ADVISORY REPORT
FINDINGS, CONCLUSIONS, AND RECOMMENDATIONS

From: Tony Leavitt, Project Planner

File: **MOMCO PRELIMINARY SUBDIVISION, FILE NO. SUB12-00382**

MOMCO PROPERTY
TREE RETENTION PLAN
12820 136TH AVENUE NE
KIRKLAND, WASHINGTON

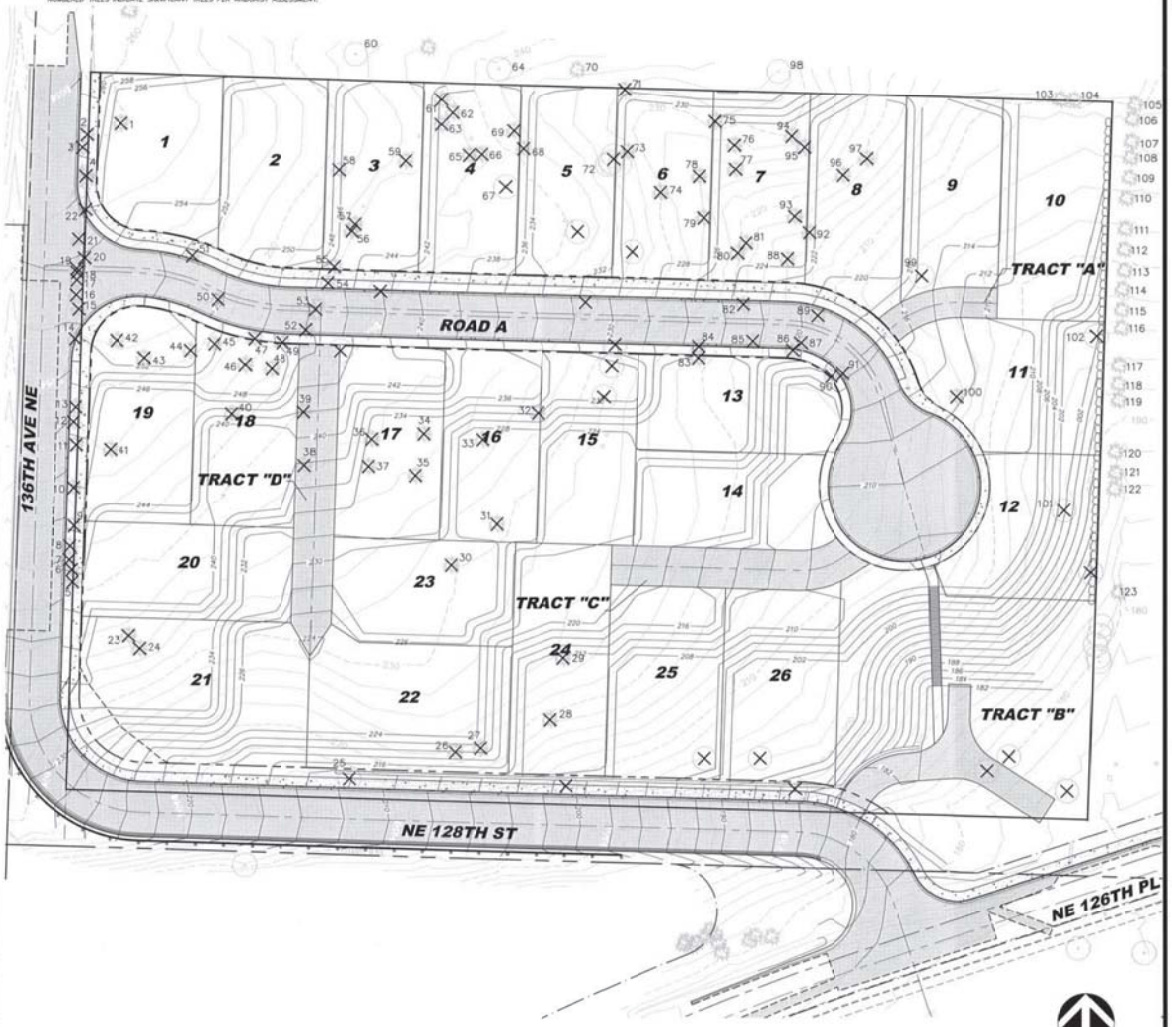
New Access Road
K. Dedicate 40 ft of right-of-way and install a 24 ft wide street with vertical curb and gutter, 4.5 ft wide landscape strips with street trees 30 ft on center, and a sidewalk along one side of the street (as depicted on sheet C7). The

sidewalk is only required on one side due to the length of the new street (modified standard recommended by Public Works).
L. The sidewalk shall extend down across the storm tract to NE 126th PL/NE 128th St. and timber stairs with code required hand rail can be used as needed (when a sloped sidewalk is not feasible).
